ADDENDUM NUMBER 1

DATE: 11/14/2024

PROJECT: Clinton Twp. Fire Station Renovations

PROJECT NUMBER: 0242-0451

2 FIRST FLOOR PLAN- PLUMBING NEW WORK
1/2" = 1'-0"

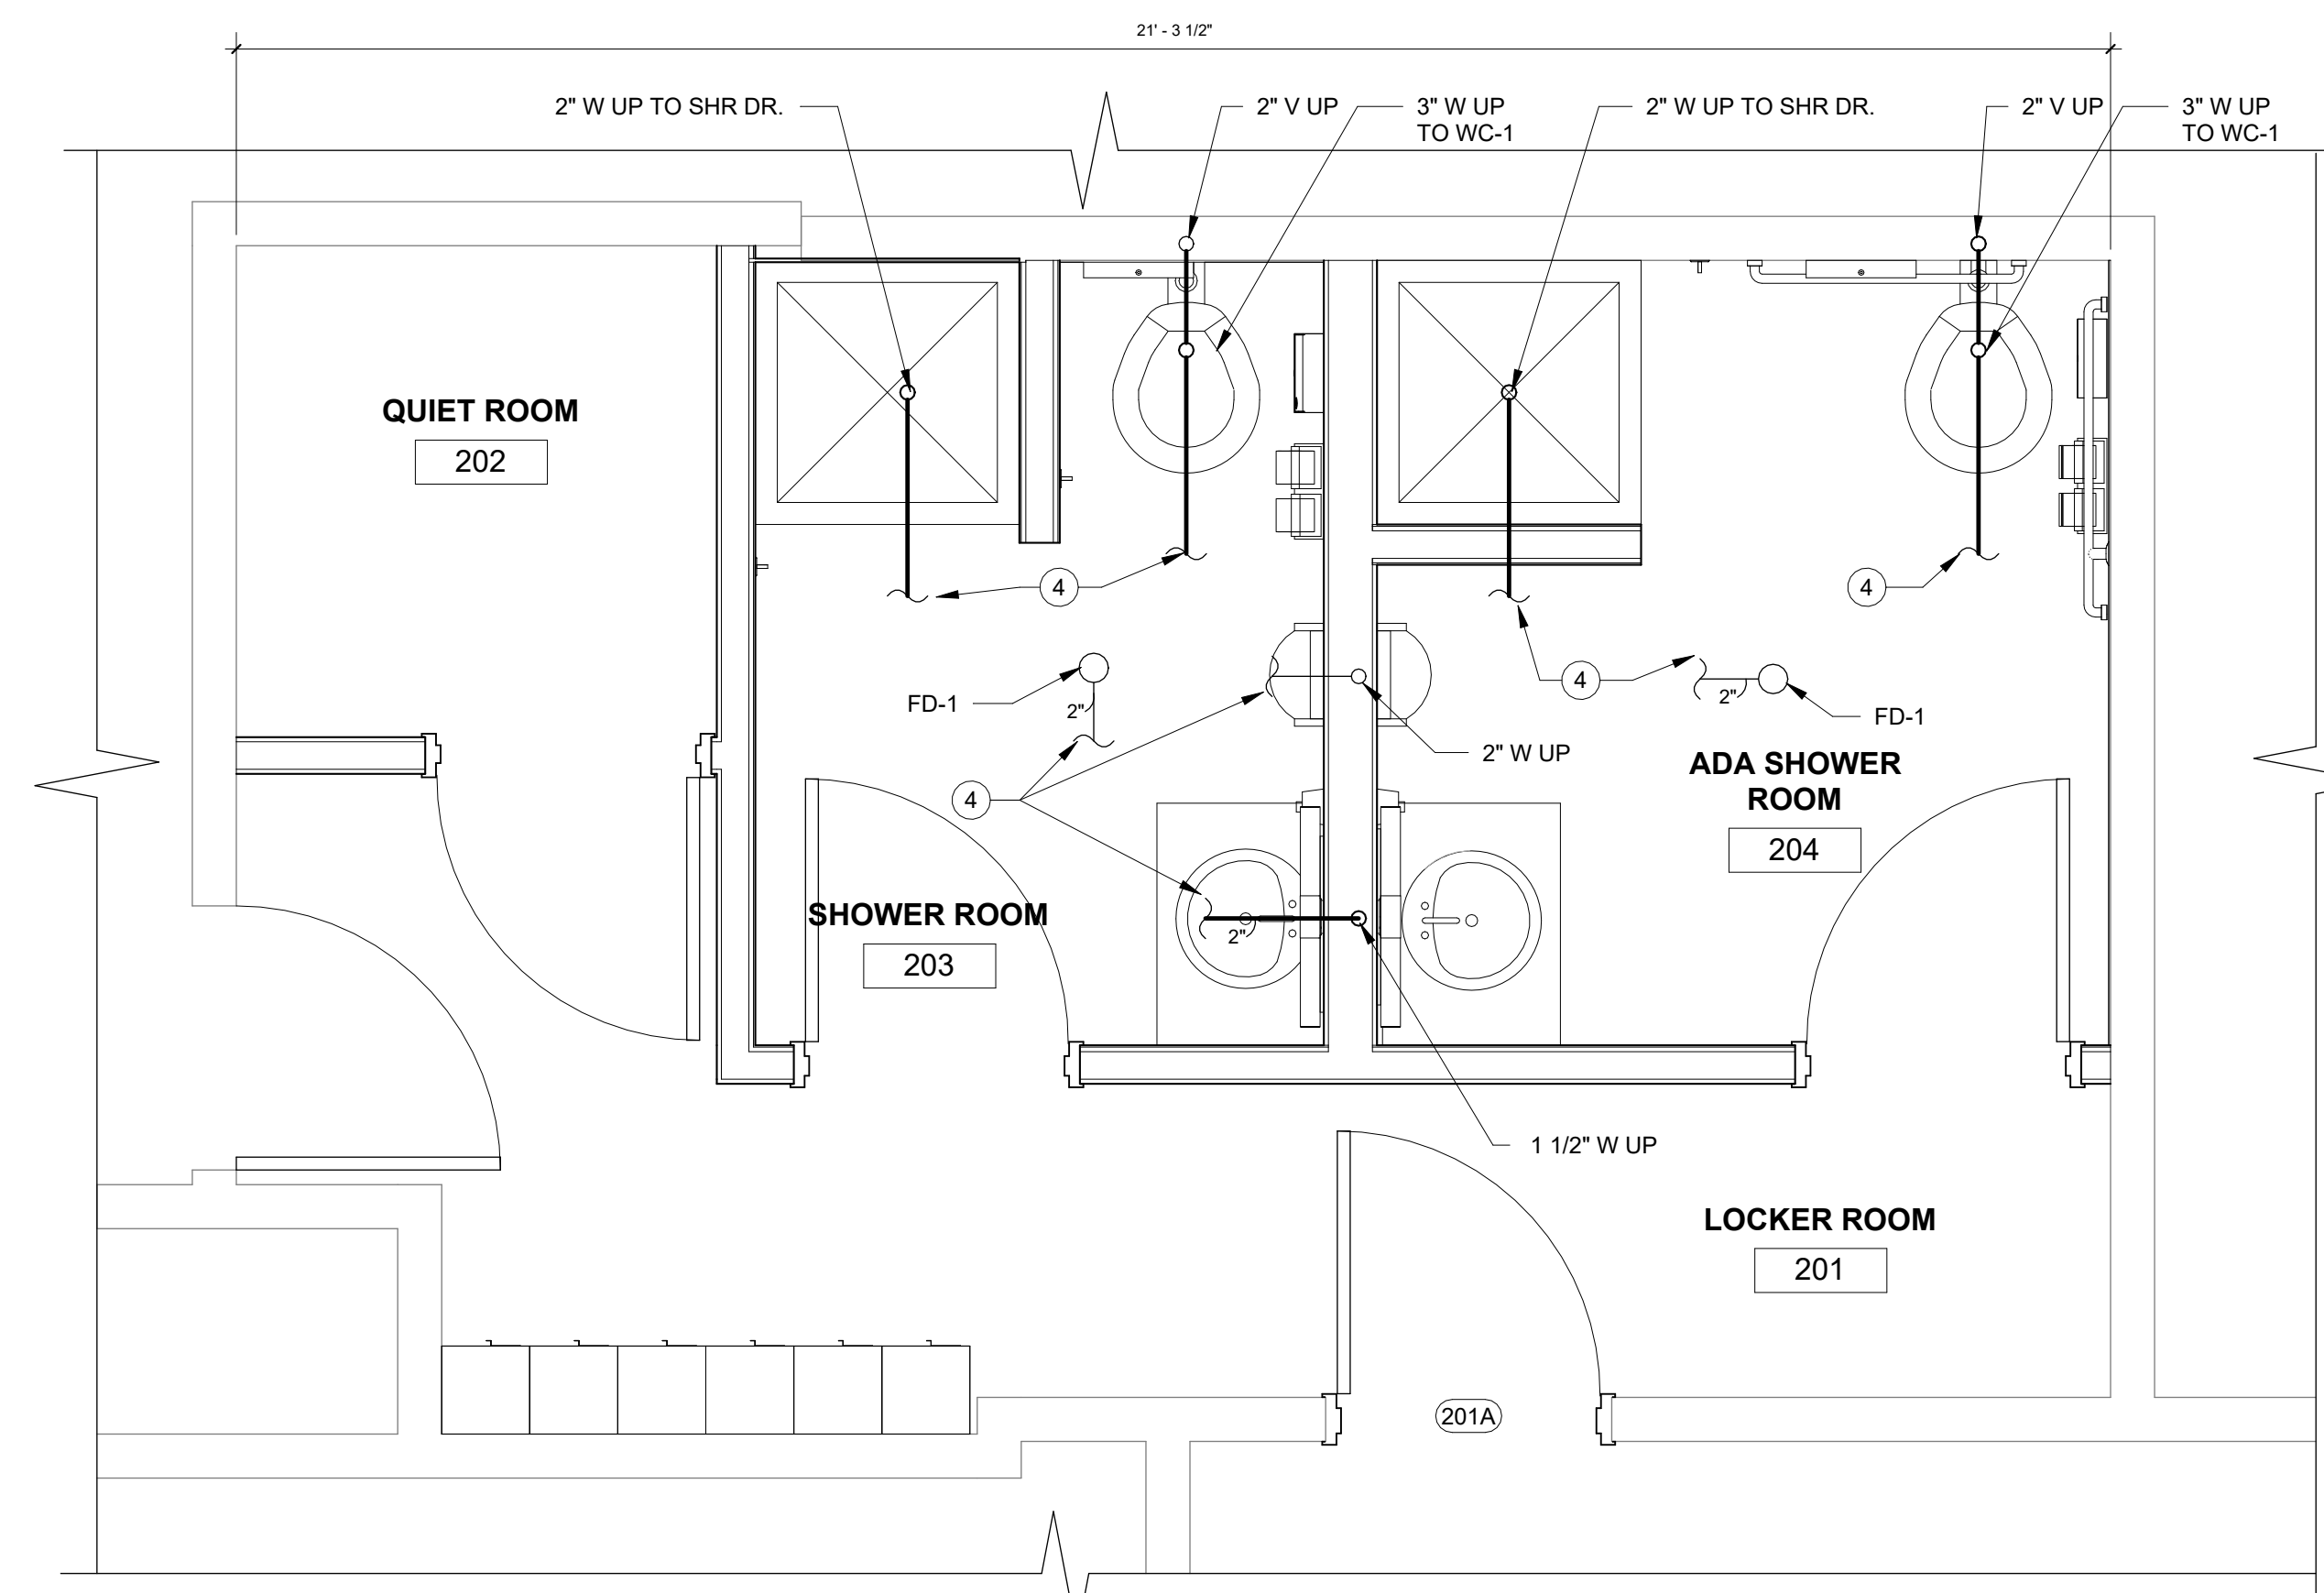
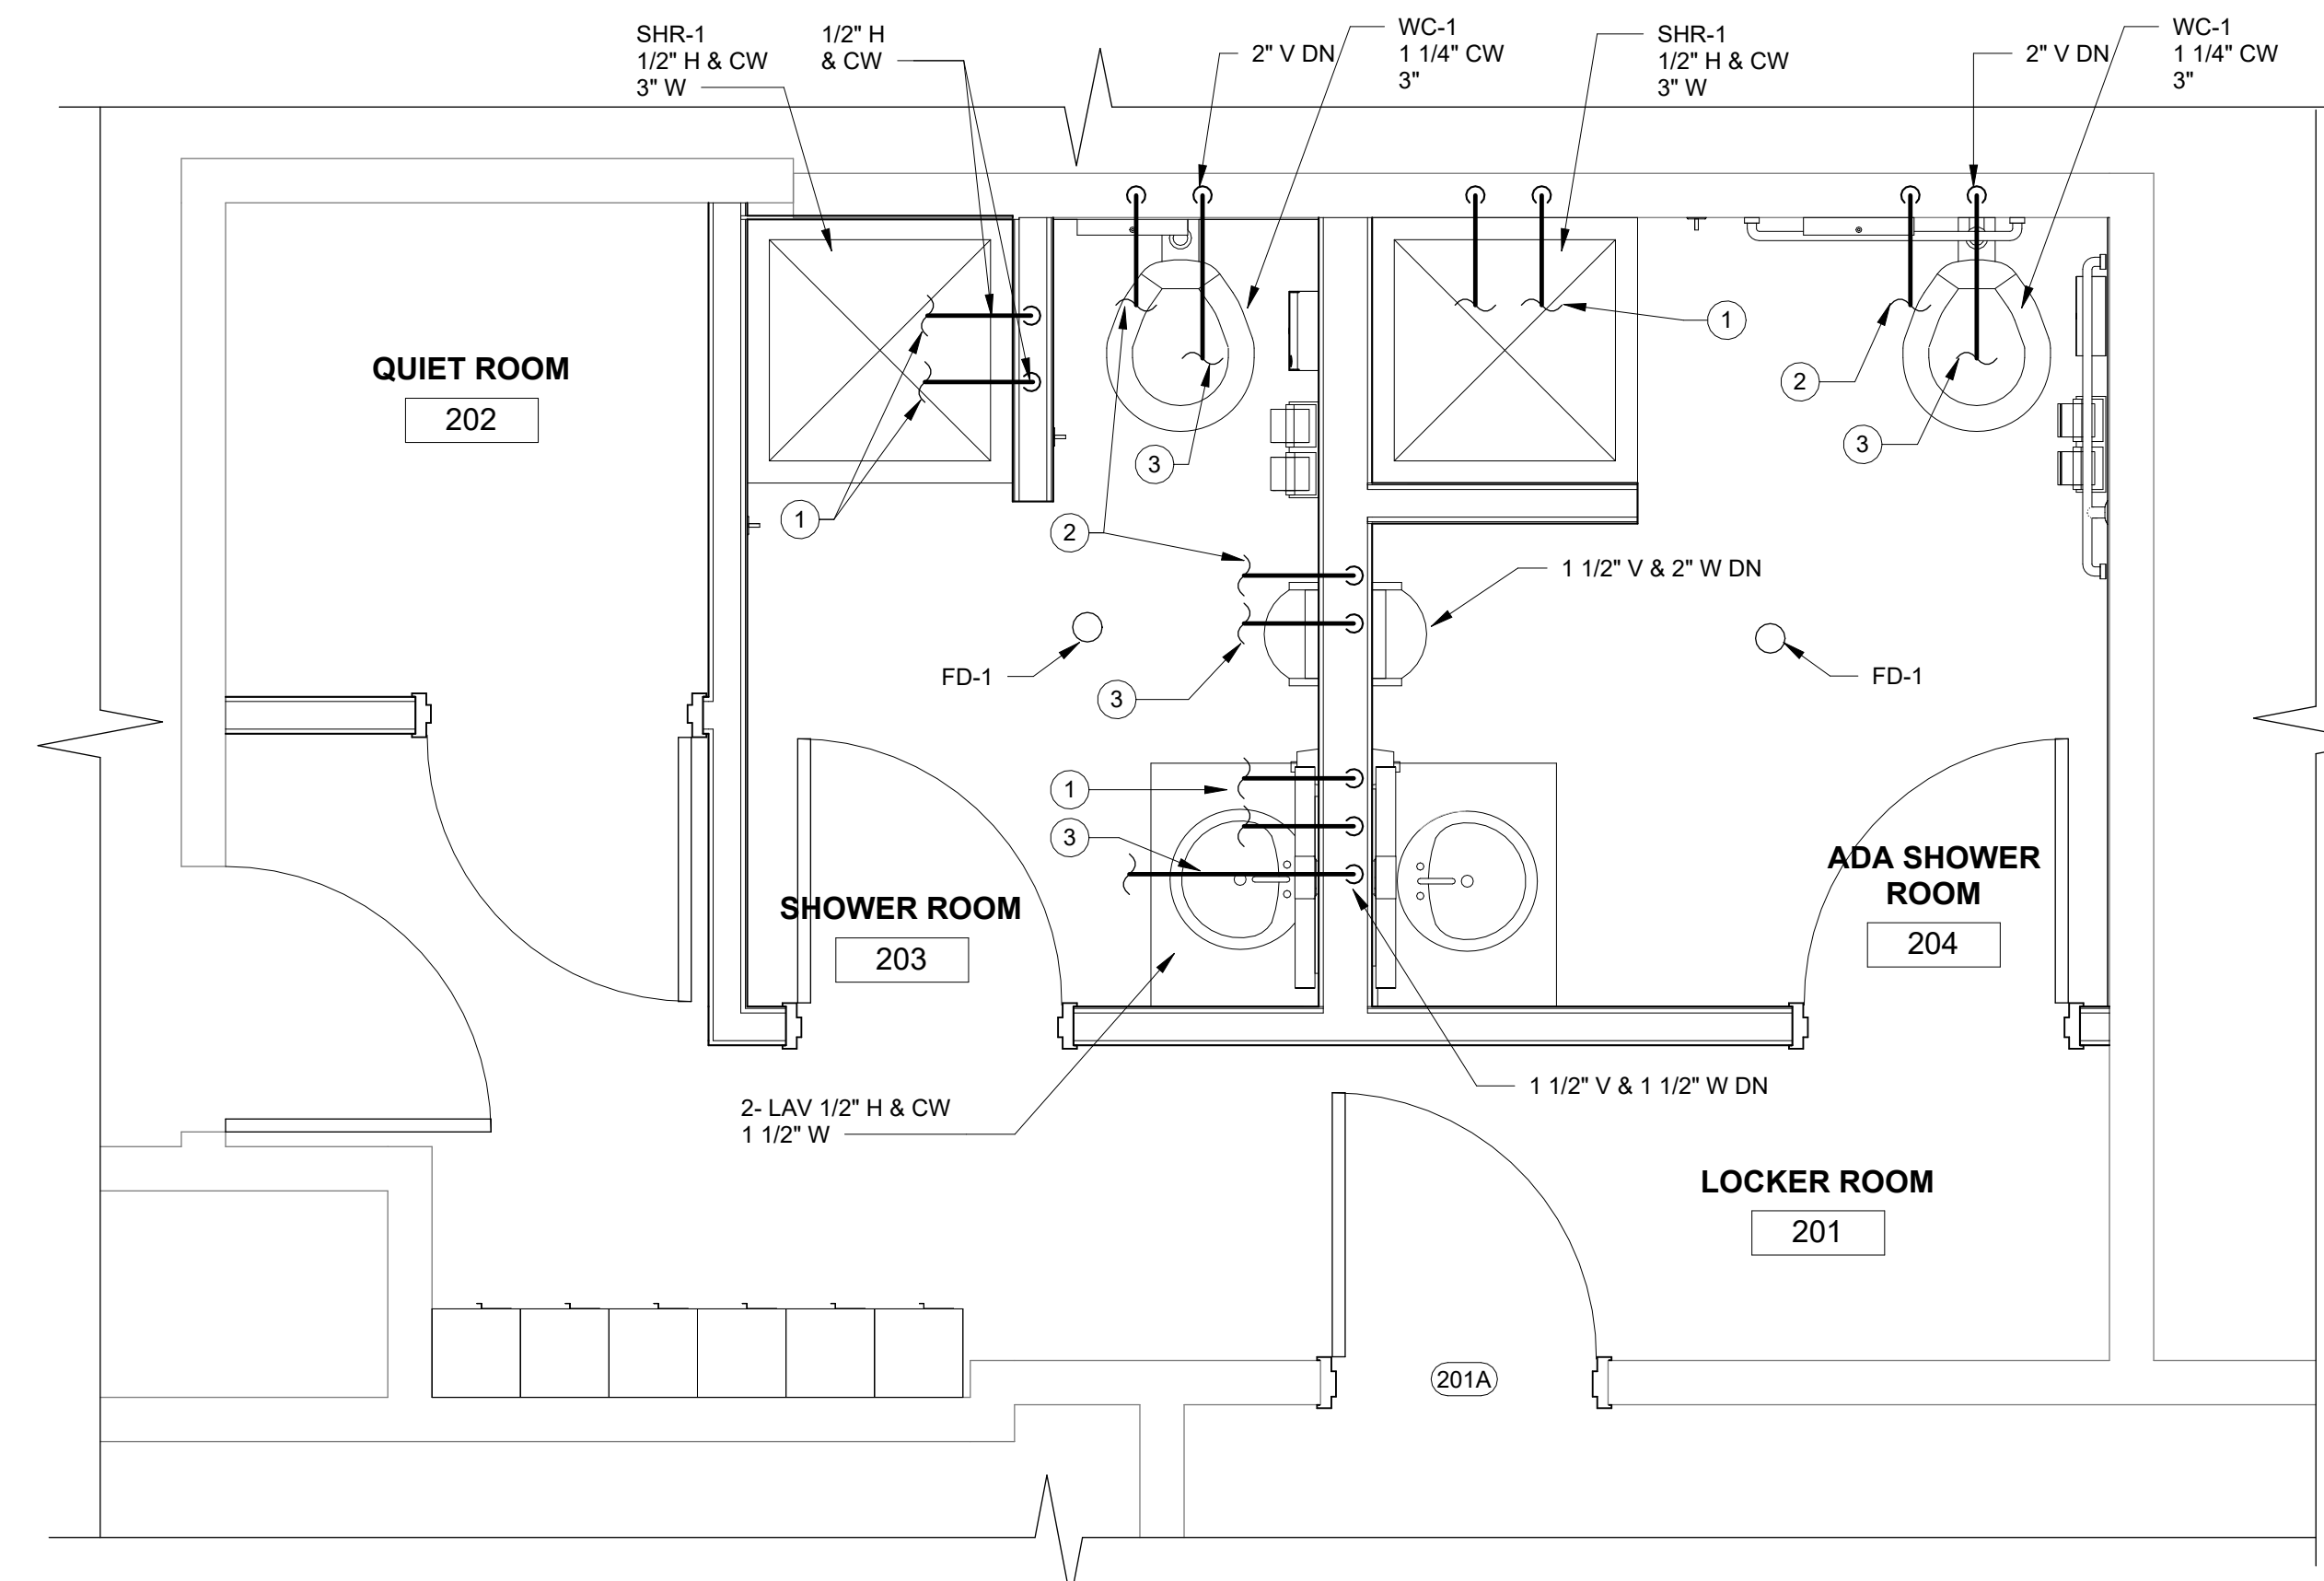
5. Q: Please provide a plumbing schedule.
A: See revised sheet P101 for plumbing schedule.
6. Q: Please clarify note 4 on page P101, detail missing.
A: Note 4 should read, "Connect drain lines from new fixtures to existing drain lines."

1. SHEET P101: (issued/reissued)
 - a. Added specifications for equipment.
 - b. Added note 4.

- ① H & CW CONNECT TO EXISTING
- ② CW CONNECT TO EXISTING
- ③ VENT CONNECT TO EXISTING
- ④ CONNECT DRAIN LINES FROM NEW FIXTURES TO EXISTING DRAIN LINES.
